# PREVOST

## WARRANTY BULLETIN

**WB16-04**

DATE :	FEBRUARY 2016	SECTION :	14 - Steering
EXPIRATION:	FEBRUARY 2018		
SUBJECT :	STEERING DAMPER SECUREMENT

Figure 1

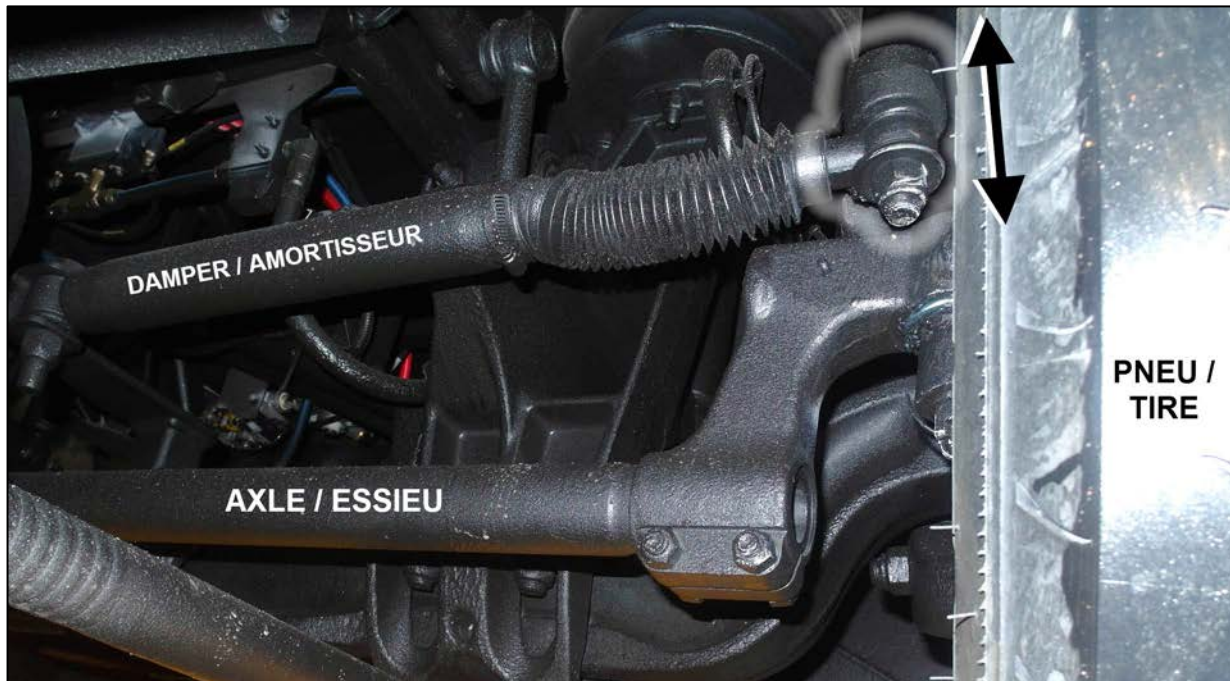
On the vehicles affected by this bulletin the steering damping cylinder rod end spherical bearing may be loose in its housing. Replace as required and secure the steering damper spherical bearing with the provided hardware.

1. Lift vehicle.
2. On front axle the left wheel, locate the steering damper spherical end.(Fig. 1)
3. Make sure there is no vertical play. (Fig. 1)
4. If the spherical bearing moves, replace by a new **660884**.

Figure 2

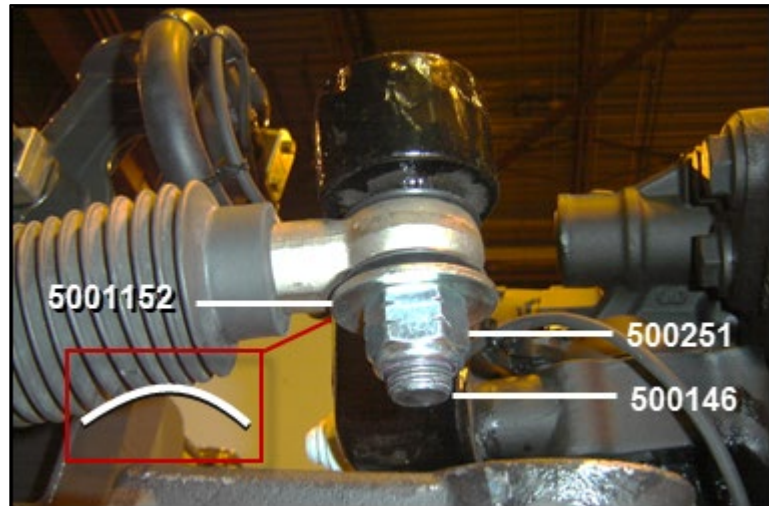
5. Add a washer under the seal é.  
Note washer orientation (fig. 2)  
**5001152** qty 1

Replace le bolt and nut :  
**500146** qty 1  
**500251** qty 1

Tighten to **110** lbf-ft.

Apply corrosion inhibitor on the new parts.
